STAFF RECOMMENDATION

NCPC File No. 6479

PATENT OFFICE BUILDING

G Street Accessible Ramps
7th and F Streets, NW
Washington, D.C.

Site plan (north entrance at top) showing relationship of proposed handicap access ramps to the sidewalk, stairs, and east-west loading dock ramp. Site plan also shows proposed landscaping in front of handicap ramps and behind loading dock ramp on both sides.

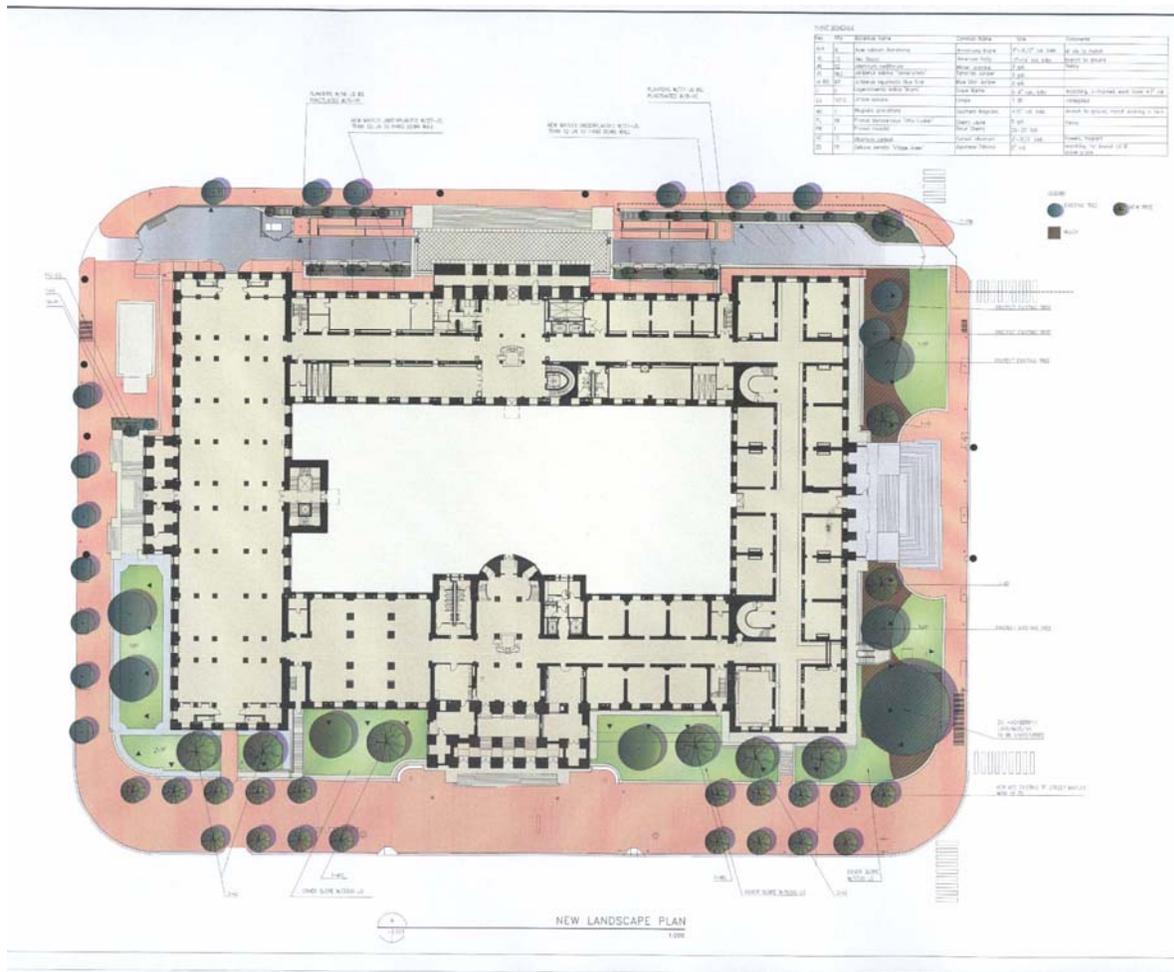
The accessible ramps do not touch historic fabric, and are inserted in front of the loading dock ramps. Because of loading dock ramps, which descend below grade underneath the extended portico plaza, the possibility of an at-grade entrance at the sides of the staircase is not possible.

The planting plan is a welcome component of the proposal and will add as much planting material as possible to the reservation, and will partially screen the accessible ramps and service ramps as well as enhance the setting of the building.
